# Access Compliance Report

## Public Rights-of-Way

Intersection ID: 15040	Main Street: TELEVISION_PL	Cross Street: WASHBURN_AV	Location: SE
ADA ID: E2C983E8348B	Ramp Type: Perp	Initial Pass/Fail: Fail	Overall Compliance: No
		Severity Score: 10

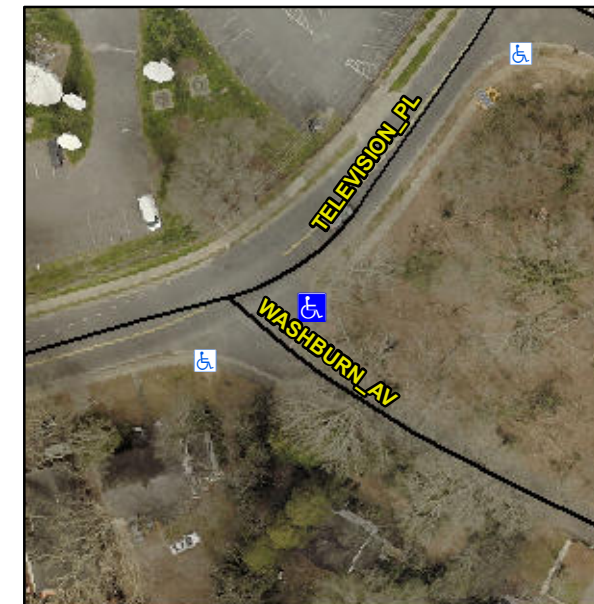
**Not Found, R304.5.1, R304.5.3**

Compliance	Description	Data	Compliance	Description	Data
N/A	Ramp Length (in)	58.0	Yes	Ramp Slope (%)	5.1
No	Ramp Width (in)	43.0	No	Ramp XSlope (%)	4.5
N/A	Flare Type LT	N/A	N/A	Flare Type RT	N/A
N/A	Flare Slope LT (%)	N/A	N/A	Flare Slope RT (%)	N/A
N/A	Flare Traversable LT?	N/A	N/A	Flare Traversable RT?	N/A
N/A	Landing Length (in)	N/A	N/A	DWS Provided?	N/A
N/A	Landing Width (in)	N/A	N/A	DWS Contrast?	N/A
N/A	Landing Slope (%)	N/A	N/A	DWS Length (in)	N/A
N/A	Landing X Slope (%)	N/A	N/A	DWS Full Width?	N/A
N/A	Landing Curb? (Y/N)	N/A	N/A	DWS Offset (in)	N/A
N/A	Shared Landing?	N/A			
N/A	Gutter Ponding?	N/A	N/A	Gutter Slope (%)	N/A
N/A	Gutter Lip Ht (in)	N/A	N/A	Gutter X Slope (%)	N/A
N/A	Painted X Walk1?	No	N/A	Painted X Walk2?	N/A
	X Walk 1 Direction	To W		X Walk 2 Direction	N/A
N/A	X Walk 1 Width (in)	N/A	N/A	X Walk 2 Width (in)	N/A
	X Walk 1 Slope (%)	5.7		X Walk 2 Slope (%)	N/A
	X Walk 1 X Slope (%)	1.3		X Walk 2 X Slope (%)	N/A

**Remove & Replace Entire Ramp.**
